Response to Local Highway Authority Comments

Land East of Claydon Road – Proposed Development

Application No. 23/00977/OUT

Figure 1: Propensity to Cycle Tool – Cherwell 001A LSOA – 2011 Census

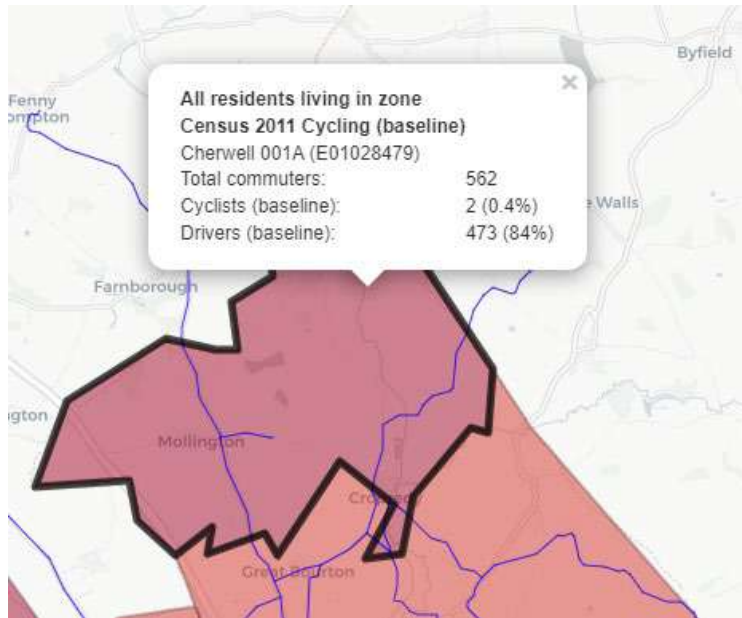
- 4.4 The LHA requested S106 contributions of £200,000 (£200 per metre for 1,000 metres) towards a new off-road shared pedestrian and cycle path.
- 4.5 The LHA's justification for the off-road pedestrian and cycle path is that an off-road pedestrian and cycle path is proposed between Banbury and Great Bourton in the Banbury Local Cycling and Walking Infrastructure Plan (LCWIP), shown as Village Route 2 in the drawing at Appendix F. The LHA consider that *"There is great pressure on Banbury LCWIP to extend the route further from Great Bourton to Cropredy."*
- 4.6 However, there is no evidence provided for the "great pressure" to extend the route, particularly as the route between Great Bourton and Cropredy does not form part of the LCWIP.

- 4.7 To establish whether there would be any “great pressure” to deliver the pedestrian / cycle route, the Propensity to Cycle Tool <https://www.pct.bike/m/?r=oxfordshire> has been interrogated.
- 4.8 For the Lower Super Output Area (LSOA) in which the site is located, 0.4% of commuters currently travel by bicycle to work.

- 4.11 For the Lower Super Output Area (LSOA) in which the site is located, under the Government Target (Near Market) scenario, 2.0% of commuters would travel by bicycle to work. Therefore, it is anticipated that three people would use the route to travel towards Banbury ($149.44 * 2.0\%$). On this basis, the footway/cycleway would cost £66,666 per person using it.

- 4.13 On the basis that, at best, the footway/cycleway would cost £66,666 person using it and the footway/cycleway is not formally part of the Banbury LCWIP, the Applicant considers that the request for this contribution does not meet the tests of paragraph 57 of the NPPF, as it is not necessary to make the development acceptable in planning terms and is not fairly or reasonably related in the context of the scale of the development.

Drawing No. **8210439/6101** Rev **D**

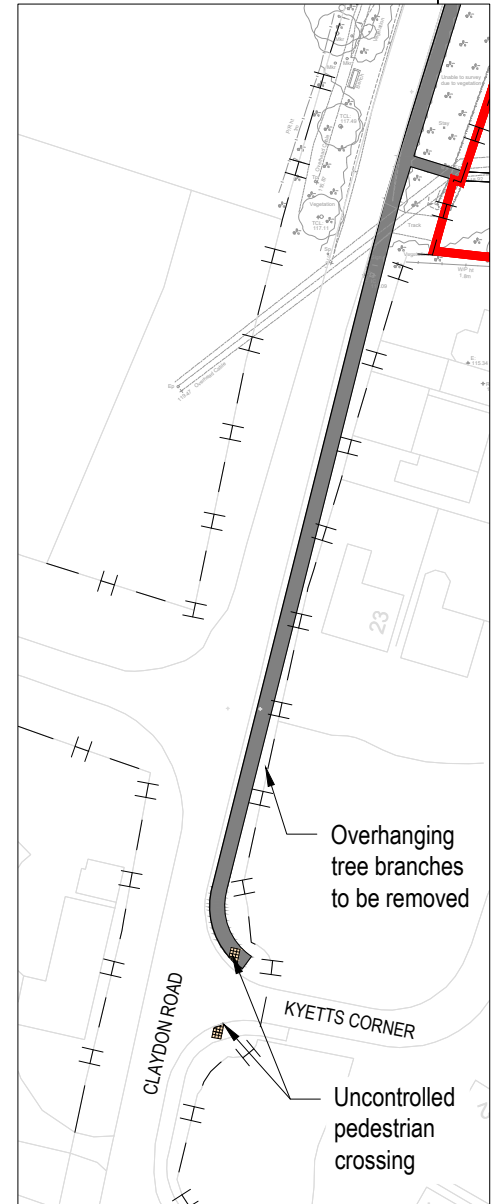
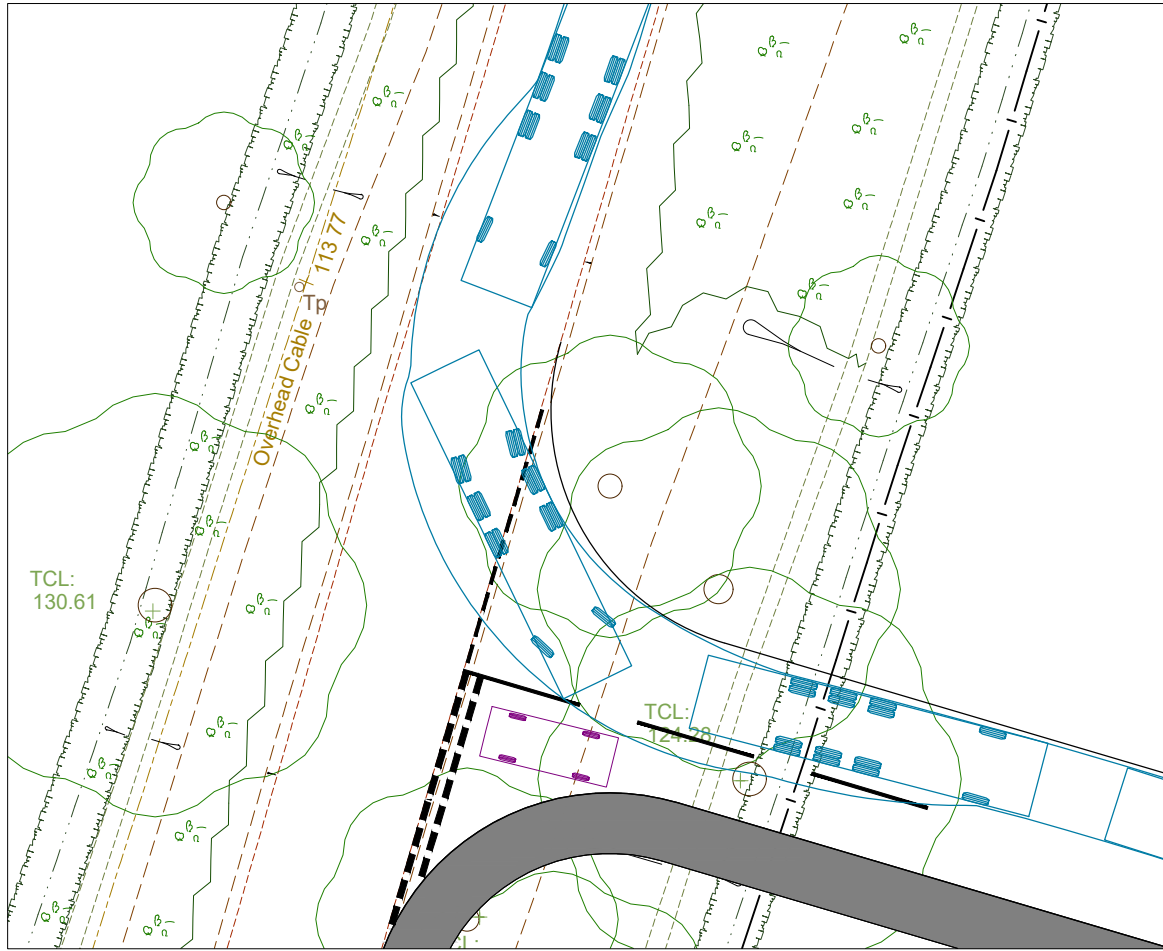
Vehicular Access- the proposed vehicular access to the site is proposed from Claydon Road via a 5.5m wide access road with 8.0m radii at the junction. An access arrangement drawing is provided at Appendix D. 4.6 It is noted that the site is some 1.5m lower than the road at the proposed access location and as such, levels within the site will be built up to ensure an appropriate gradient of 1:20 is achieved along the site access. A site access/clarendon Road junction design layout details with dimensions with better clarity for assessment would be needed to facilitate the approval of this outline application from the transport perspective.

Roads comments: -The suite of application plans does not provide much detail regarding the access with carriageway and footway widths and therefore it is not clear if what is being proposed is feasible. Without this information the LHA would recommend that this application is opposed until these dimensions and information below are provided.

- 3.1 Although some site access dimensions were shown on the access arrangement drawing 8210439/6101_C, additional dimensions have been shown on updated drawing 8210439/6101_D at Appendix B to close out Point 2a of the LHA's response.

D	Notes and dimensions revised.	17/07/23 T. Hart	AD
C	Architects layout added.	29/03/23 T. Hart	JB
B	Access location updated.	06/02/23 T. Hart	AD
A	Visibility Splays updated.	12/12/22 D. Steenkamp	JB

Swept Path Analysis

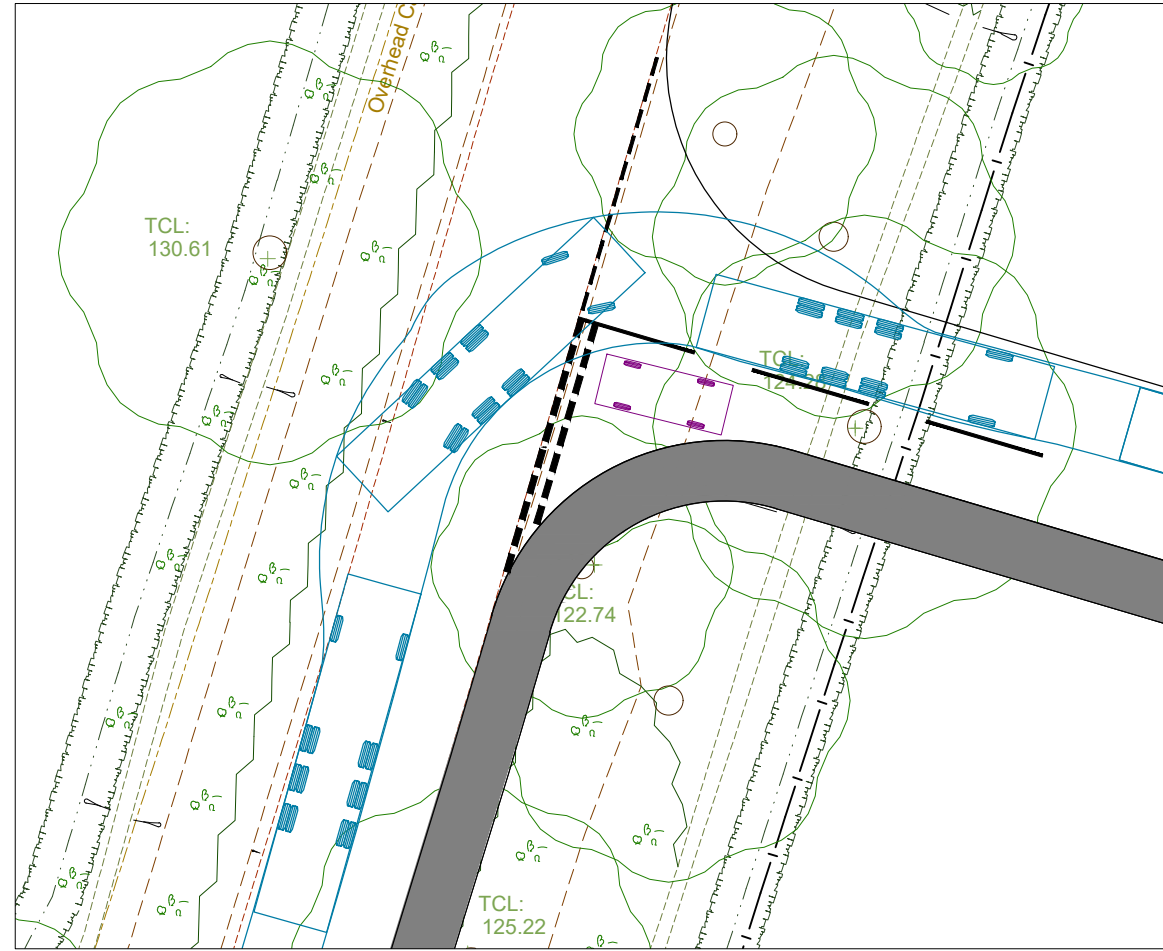
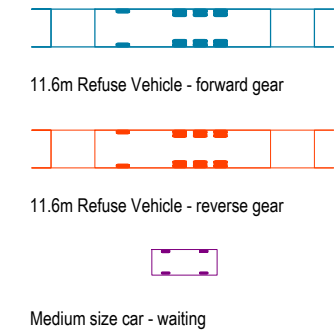
- 3.2 In its consultation response, the LHA stated that *"Vehicle tracking at the access largely covers opposite lanes on all movement which could cause collisions, this should be addressed by the Applicant"*.

- 3.3 Paragraph 6.8.1 of Manual for Streets states that *"The design of local roads should accommodate service vehicles without allowing their requirements to dominate the layout. On streets with low traffic flows and speeds, it may be assumed that they will be able to use the full width of the carriageway to manoeuvre"*.

- 3.4 As outlined in the Transport Statement, Claydon Road is very lightly trafficked, with a weekday (5-day) average of 439 vehicles travelling northbound and 390 travelling southbound. Given refuse collection would be a once per week occurrence, the likelihood of a car travelling along Claydon Road at the same time as a refuse vehicle is considered very low.

- 3.5 Furthermore, the swept path analysis at Appendix C demonstrates that sufficient space is available for a car and refuse vehicle to pass each other at the site access and on Claydon Road.

- 3.7 Based on the above, it is considered that no alterations are required to the proposed site access arrangement, thereby addressing Point 2d of the LHA's response.

*Insufficient vertical clearance
beneath existing tree canopy*

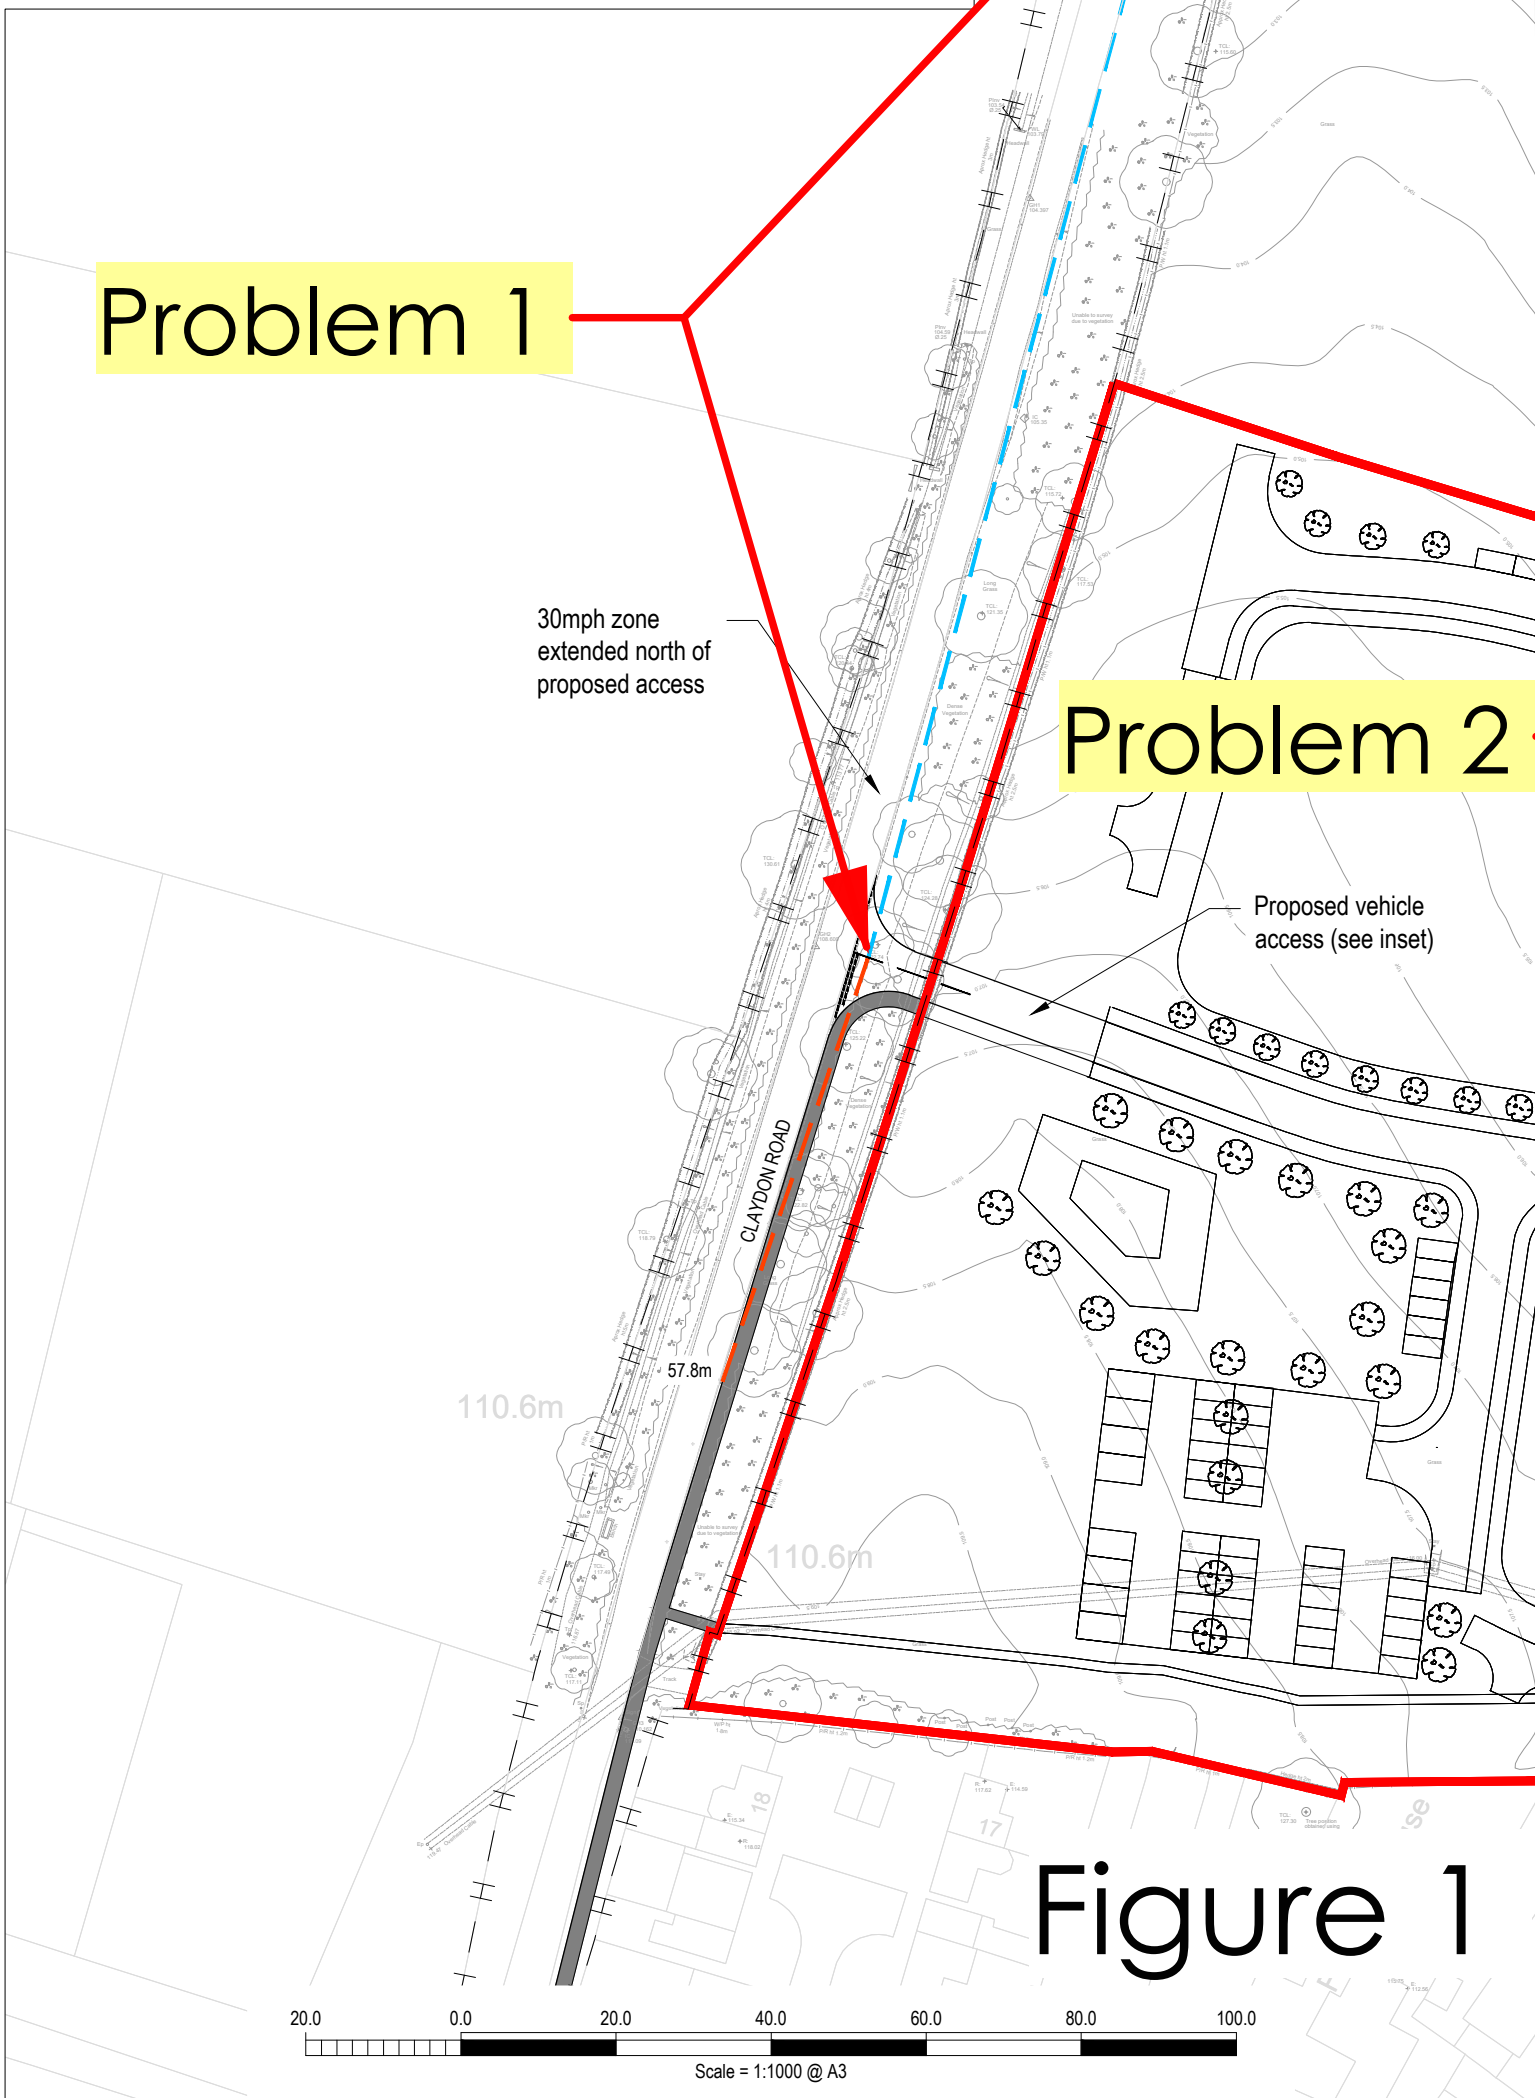
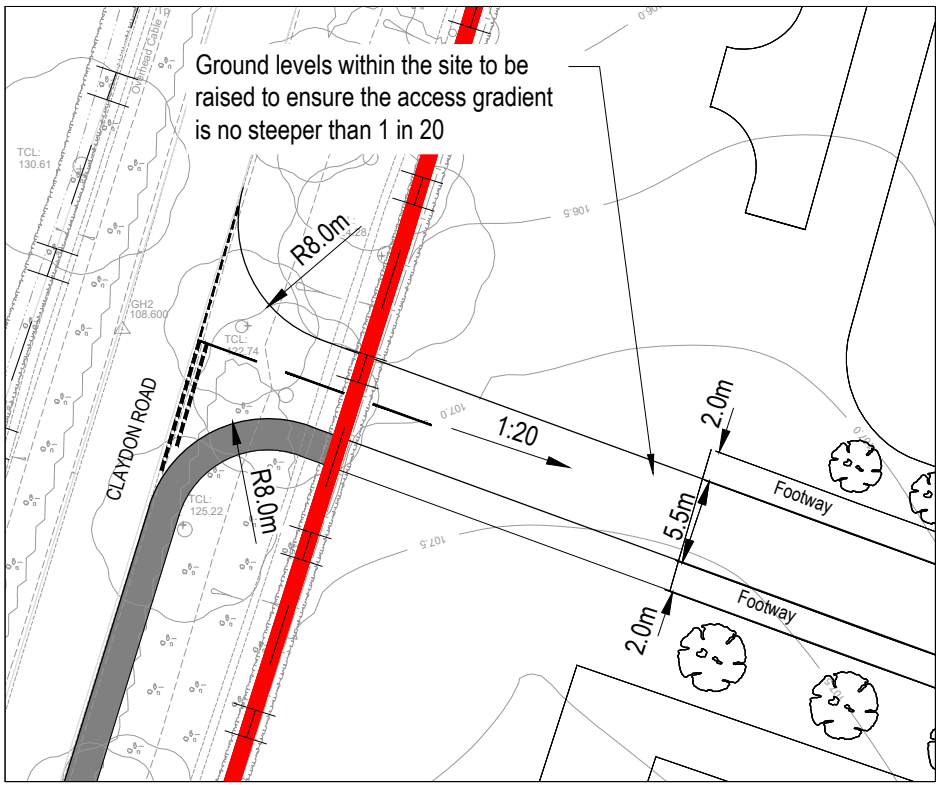
Location: Proposed footway.

Summary: Risk of pedestrian injuries.

The proposed footway between the site access and Kyetts Corner will pass under an existing tree. There is insufficient vertical clearance (headroom) under the tree canopy which may lead to pedestrian injuries.

It is recommended that measures are taken to ensure that there is sufficient vertical clearance beneath the existing tree canopy.

RSA Problem	RSA Recommendation	Design Organisation's Response	Overseeing Organisation's Response	Agreed RSA Action
1	<p>It is recommended that the extent of vegetation clearance is clearly indicated on the drawings. It should be noted that the extent of existing vegetation growth as, observed on site both within the verge and around tree trunks, was not of a uniform growth or spread as is suggested on the drawings. The lack of uniformity should be accounted for when determining the impact on the visibility splays and the extent of clearance.</p>	<p>The recommendation of the RSA is agreed, and the proposed site access drawing has been updated to identify the extent of vegetation removal.</p>		
2	<p>It is recommended that measures are taken to ensure that there is sufficient vertical clearance beneath the existing tree canopy.</p>	<p>The recommendation of the RSA is agreed, and the proposed site access drawing has been updated to identify that any overhanging branches will be cut back to provide sufficient vertical clearance beneath the tree canopy.</p>
